REQUEST FOR INFORMATION DATE: April 20, 2016 NO.: RFI-044

Project Name: Webster University Interdisciplinary Science Building Project No.: 15051

Subject: Custom fin detail clarifications

1 MILLION WITH PROJECTED COVER

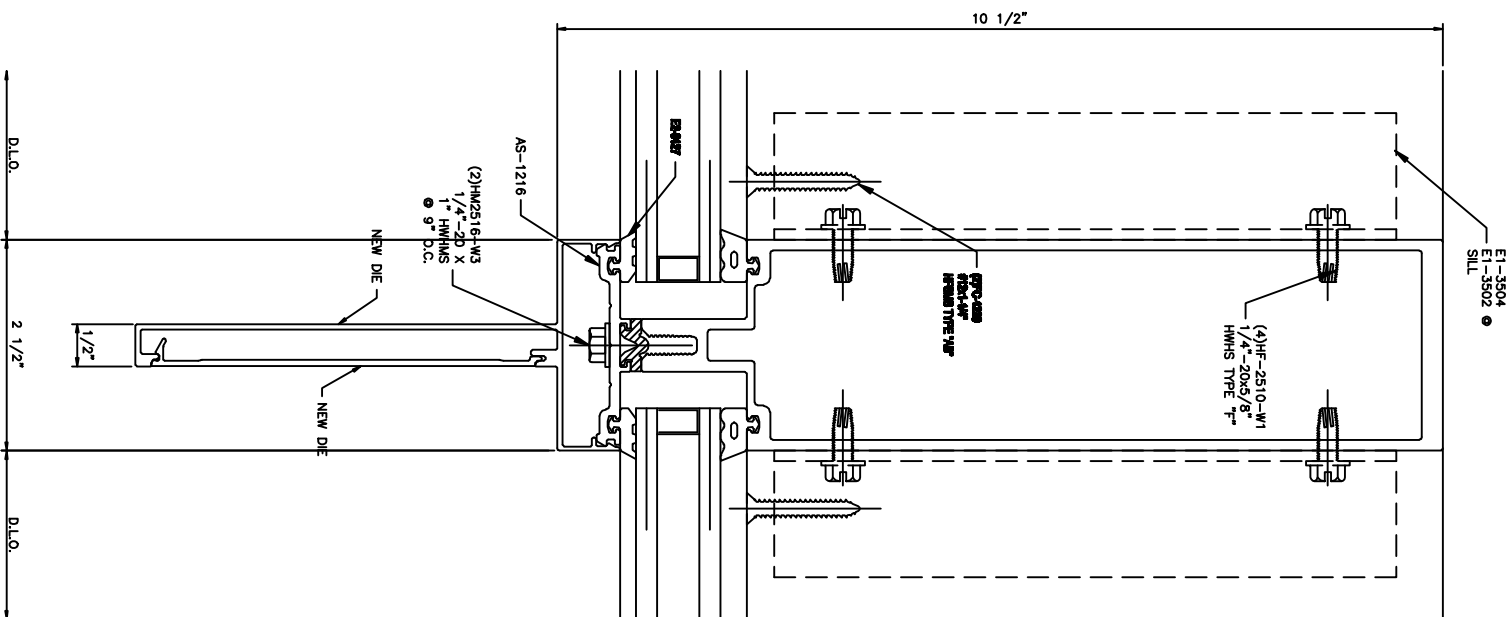
See attached detail 12/A0421 of the architectural drawings illustrating the custom fin design. In order to extrude this we had to modify the design slightly in order for it to work (see attached). The drawings call for closures at top and bottom of the fins as well as movement splices.

NGG requests we cap off the tops and bottoms and eliminate any splices. Please confirm.

If we cap off only at the top/bottom of the wall and use splices in between we allow an opportunity for water to get in to the cavity, build up and eventually freeze. This freezing would more than likely cause the snap in shape of our design to pop off the building. If we cap off each end of each piece we eliminate that possibility.

NGG's proposed snap cover does not satisfy the design intent.

The design intent is to have a seamless continuous appearance for the fin.

- 1) The proposed snap cover (fin) creates a break at the horizontal movement joint which does not satisfy the design intent.
- 2) We are concerned that the additional snap piece in the proposed snap cover extrusion might interfere with the movement of splice at the horizontal movement joint and changes the appearance.
- 3) Potential solution: Snap cover can be capped at the top, spliced at the horizontal movement joint, capped at the bottom of the lower piece with some holes to allow for moisture drainage.
- 4) Submit a sample of fin based on proposed design for consideration.

12 PLAN DETAIL - CURTAINWALL SNAP COVER

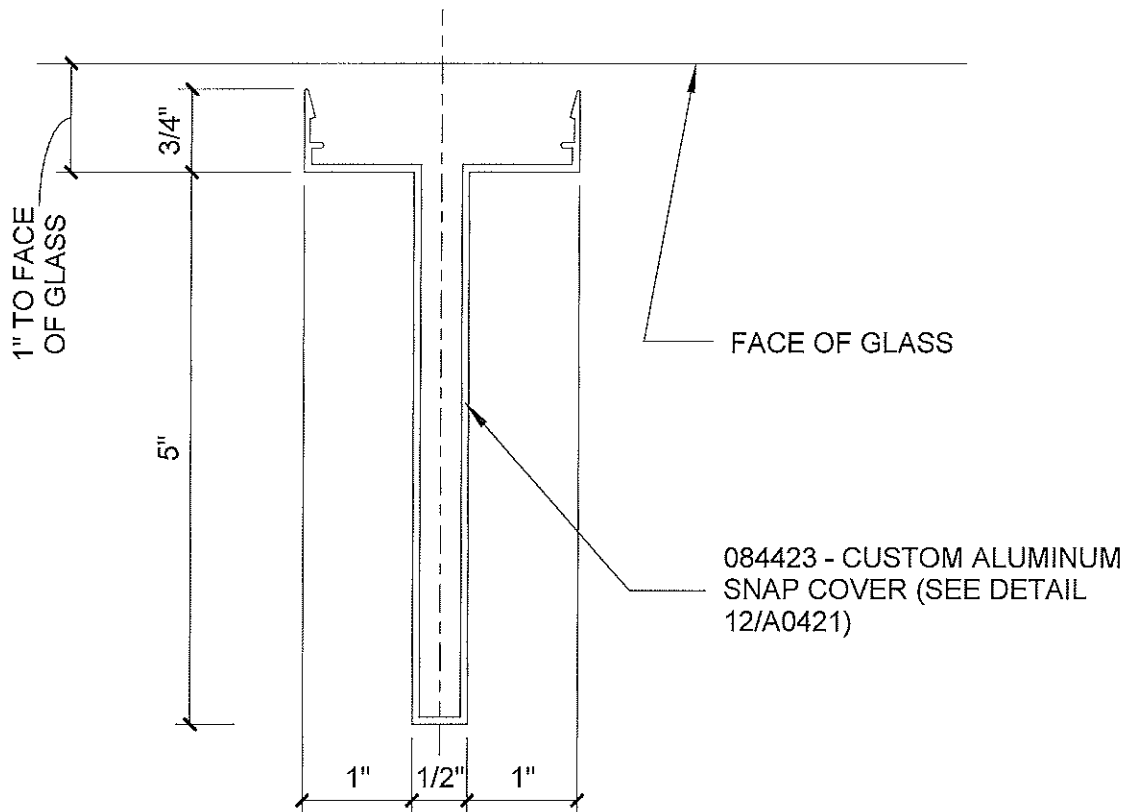
CURTAINWALL MANUFACTURE TO PROVIDE CLOSURES (TOP & BOTTEM FOR CUSTOM ALUM SNAP COVERS) ILLUSTRATE IN SHOP DRAWINGS BOTH CUSTOM ALUM CLOSURES AND MOVEMENT SPLICE JOINTS
